PRE-DESIGN INVESTIGATION WORK PLAN
 FORMER GREEN BAY MANUFACTURED GAS PLANT
 WISCONSIN PUBLIC SERVICE CORPORATION
 CITY OF GREEN BAY, WISCONSIN

Re: Review of the Pre-Design Investigation Work Plan – Revision 0, Former WPSC Green Bay MGP, Green Bay, Wisconsin

Attachment 1 – Comments on the Pre-Design Investigation Work Plan

FIGURE 8

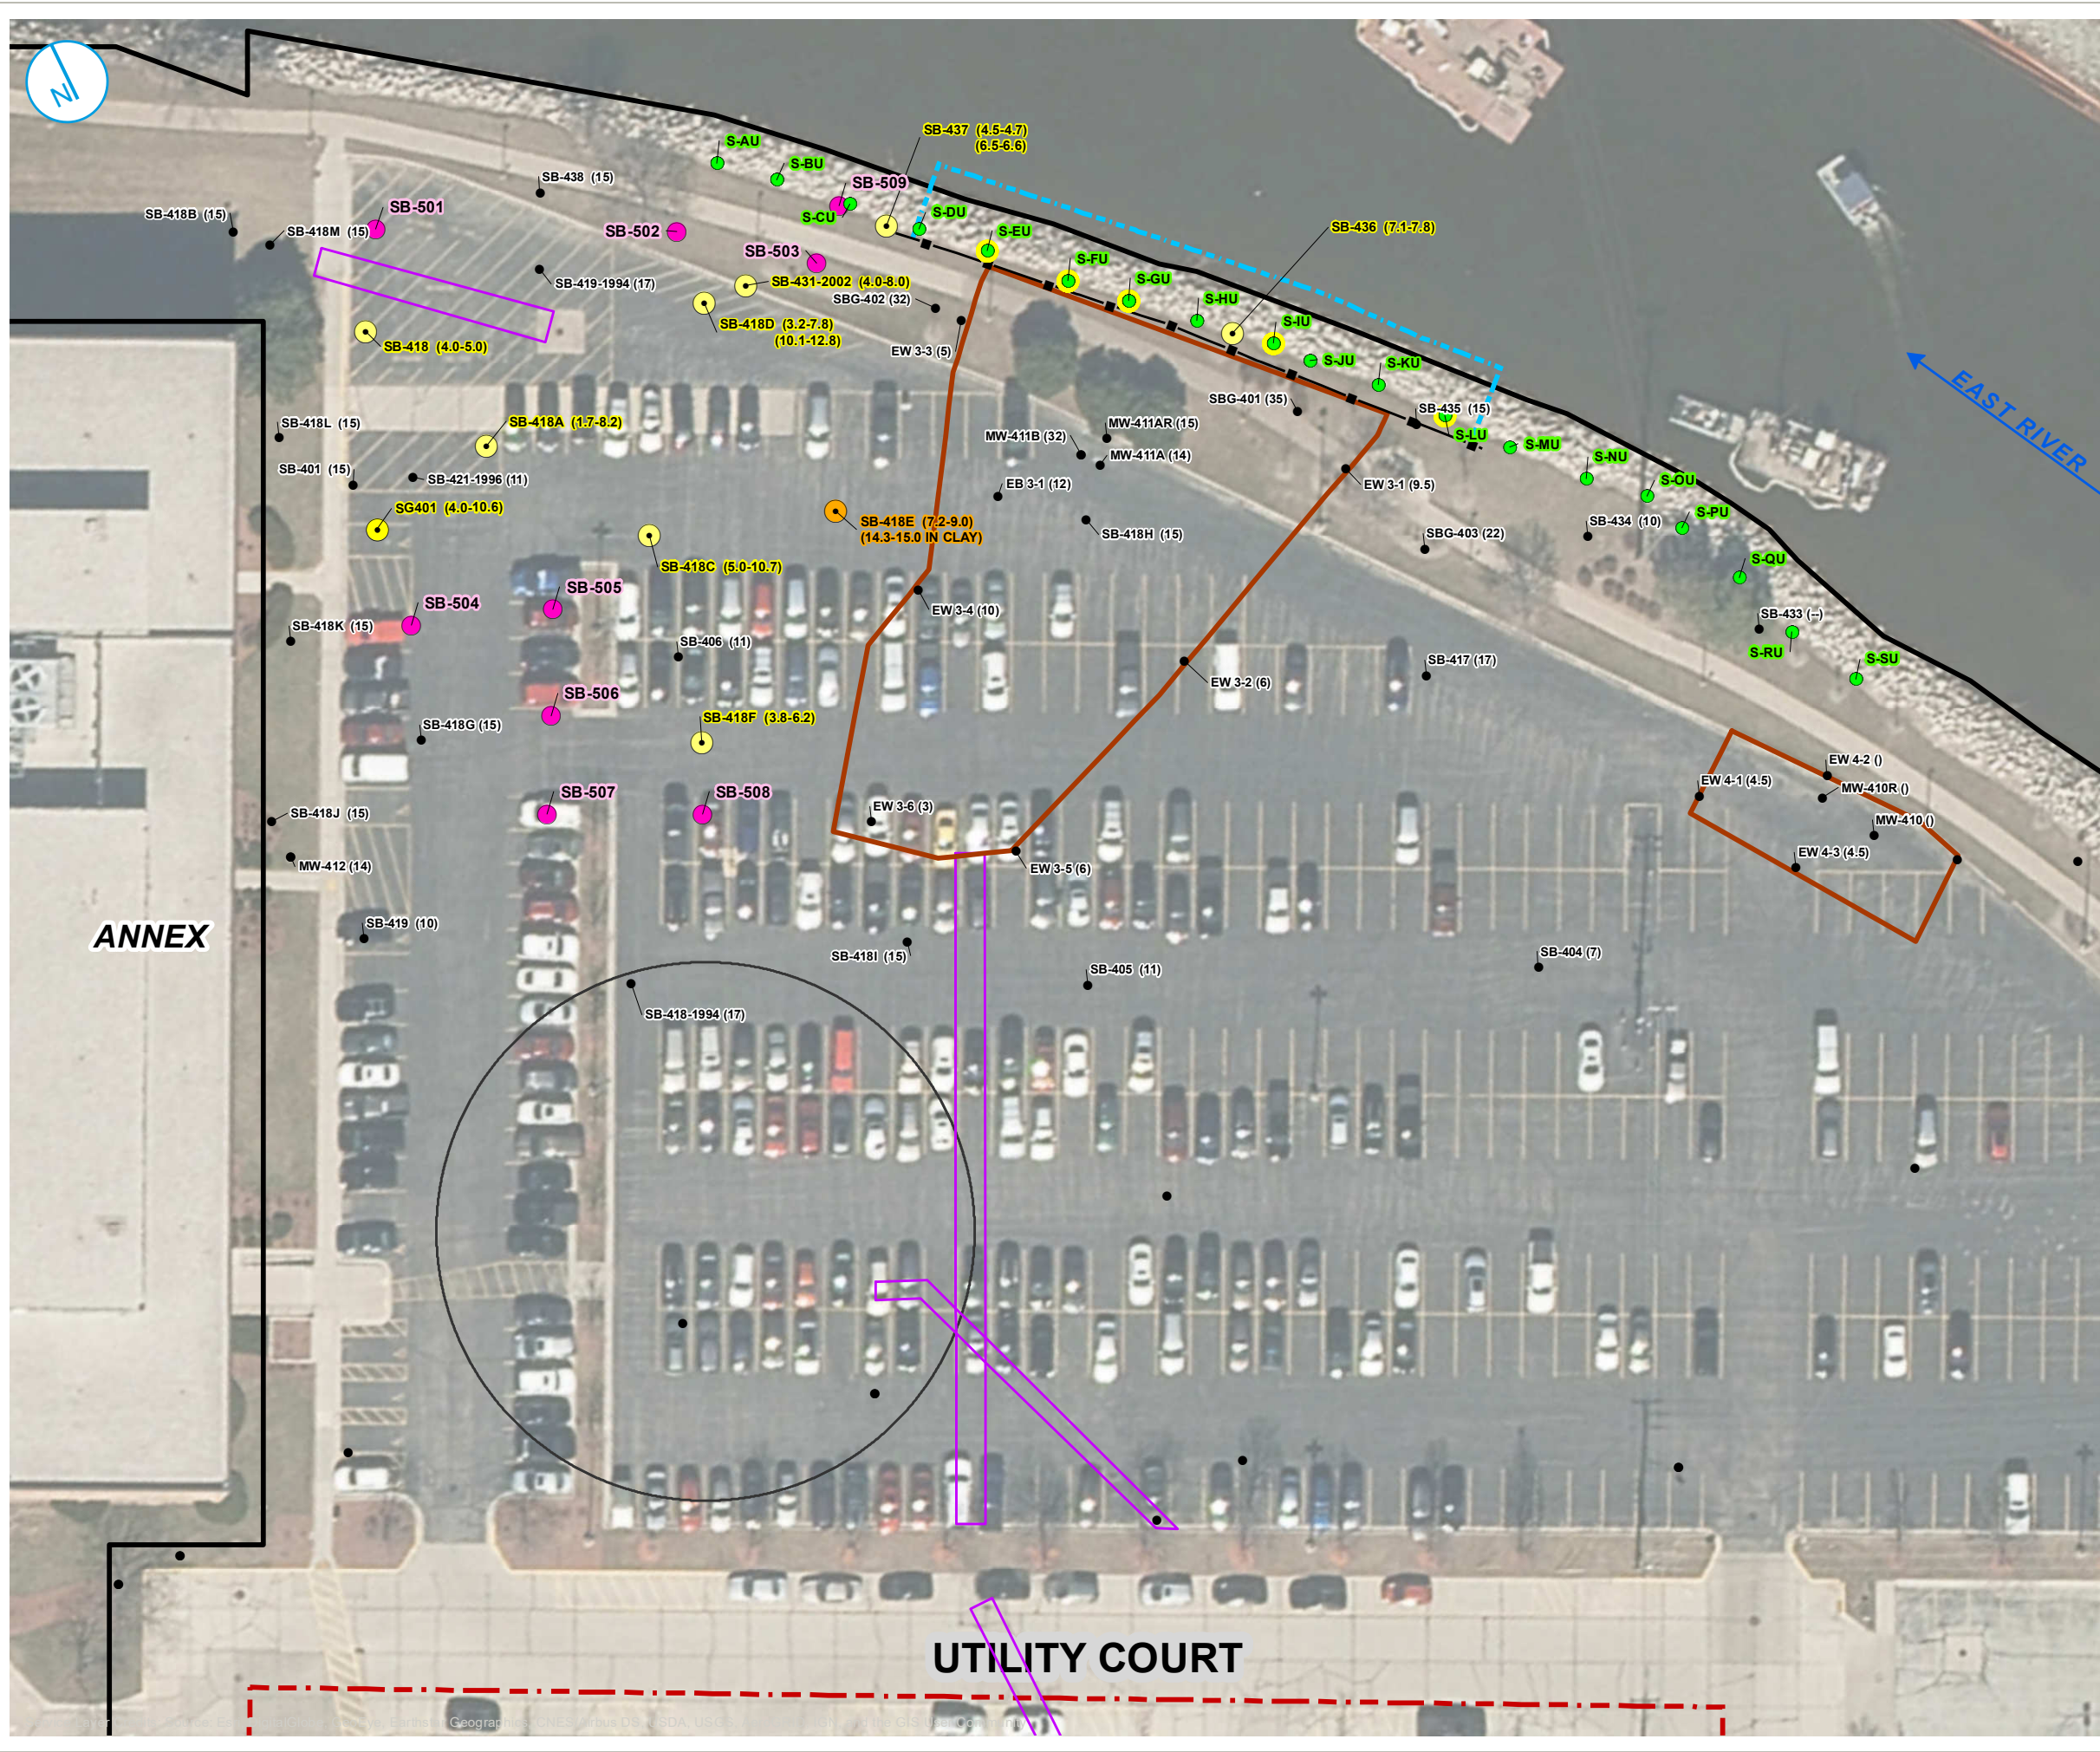
2. Additional soil borings are recommended along the land-side of the sheet pile wall installed as part of the 2003 soil removal action. Approximate suggested locations are shown as red rectangles on the annotated Figure 8, PDI Work Plan (Attachment 2). The purpose of the sample locations would be to see if NAPL exists at any depth behind the wall, either outside the 2003 removal action footprint, or underneath the footprint, or within if NAPL migrated to a more permeable layer.

15. Section 3.3.1 – Please include the spacing that will be utilized for the contingency borings and update Figure 8 to include potential locations.
16. Executive Summary, Section 3.4, and Table 1 - It is not clear if biotrap will be deployed only to assess the microbial population naturally present in the COPC-impacted groundwater (as described for data gap 4), or if stable isotope probing (using naphthalene) will be conducted (as described in Table 1). No mention of lab analyses such as CENSUS qPCR or QuantArray for assessing the diverse microbial population is made. If biotrap will only be used to label naphthalene and track its biodegradation into biomass and CO₂, provide rationale how this would be used as a line of evidence for benzene and benzo(a)pyrene natural attenuation.
